SI M11 01 17
Engine

December 2018
Technical Service

FAULT 118002 - MIXTURE TOO RICH SETS DURING WINTER WITH COLD AMBIENT TEMPERATURES

This Service Information bulletin supersedes SI M11 01 17 **dated January 2018**.

4. Inspect the version of the cylinder head cover

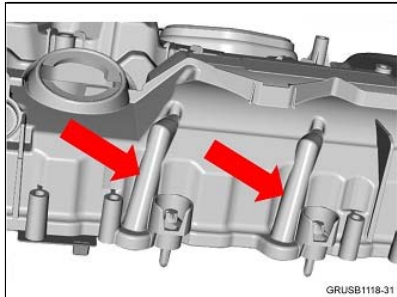
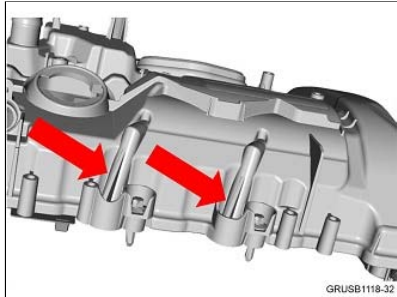
GRUSB1119-31	The older version is shown to the left.
 GRUSB1119-32	The newer version is shown to the left Note: This updated version can be identified by the additional supports on crankcase ventilation ports

Replace the cylinder head cover and profile gasket if the older version is equipped.
